## Public comment response

Re: Project File #608020 Cape Cod Bridges Project

The Draft Environmental Impact Report Section 4.3.2 illustrates and describes the Bourne South Quadrant's shared use facility as follows:

Figure 2 - Location of proposed overpass versus existing path plan

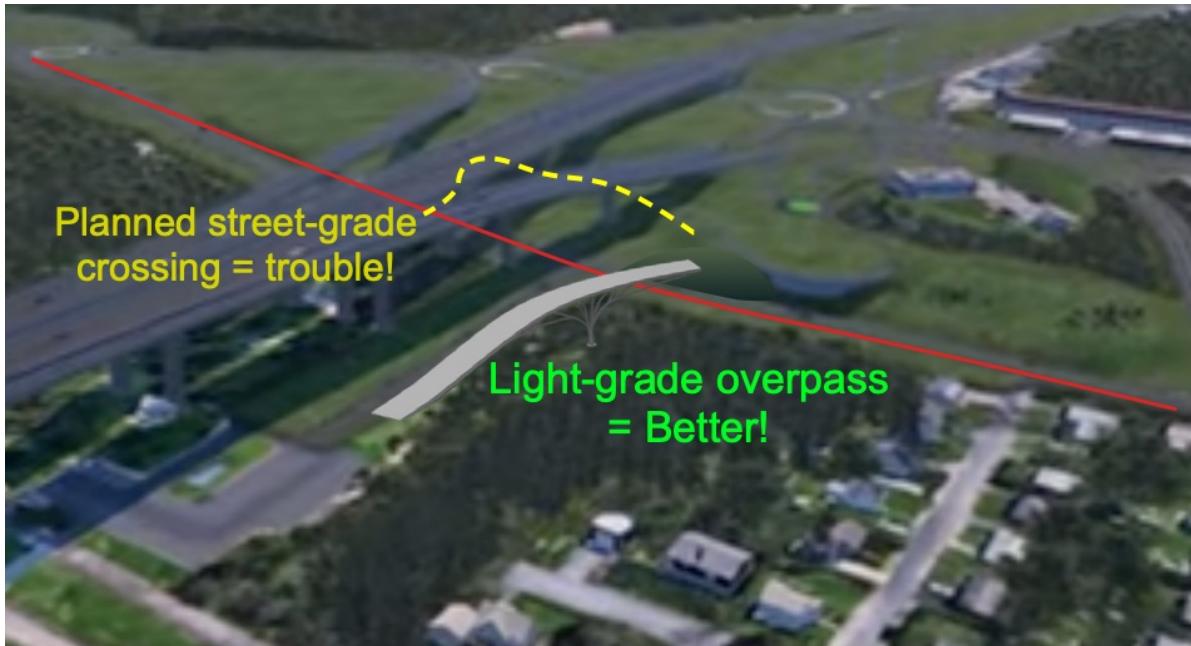
A light, ramped, grade-separated bike & walker overpass is a simple cost-effective solution that **eliminates the issue entirely** by leveraging the existing site elevation, the already-planned retaining wall, and already-available land. Figure 2 illustrates this.

- **Better supports event surges.** Large-scale events can proceed without closing the Canal Service Road or requiring law enforcement control. Smaller events won't cause otherwise-likely traffic backups.
- **Further encourages usage.** Encourages increased year-round use by locals and visitors by eliminating fear of car collisions.
- **Improves site impact.** Utilizing existing right-of-way maintains land alignment, leverages the descending elevation, and eliminates extra berms and erosion control.

- **Simplifies canal bike path connection.** The overpass can safely exit near most users' destination - the bike path.
- **Eliminates vehicle-human conflict.** Period. The overpass entirely avoids the interaction between bikes & walkers, and eliminates driver interference.

**Figure 3 - Descent Ramp into existing public property**

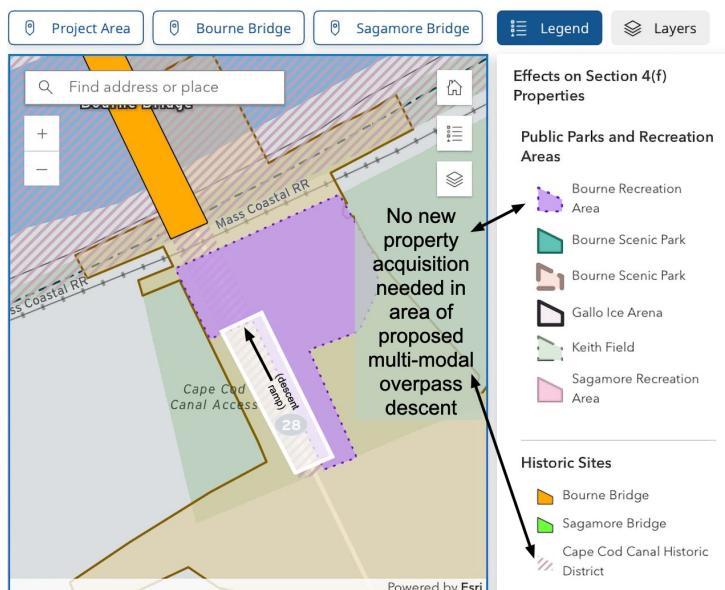
- **The change leverages planned structures.** A structural berm and major path descent are already included in the current plan; these elements can be reworked to form the southerly approach to the overpass. The northerly descent can be accommodated by a light, non-vehicular structure. A preliminary examination by project engineers indicates that replacing the planned path with an overpass is feasible.<sup>2</sup>
- **No new property required.** The northern side of the overpass, which constitutes the descent over grade, can descend into the existing Bourne Recreation Area and Cape Cod Canal District property. No property taking is required. See rough placement illustrated in Figures 3 & 4.
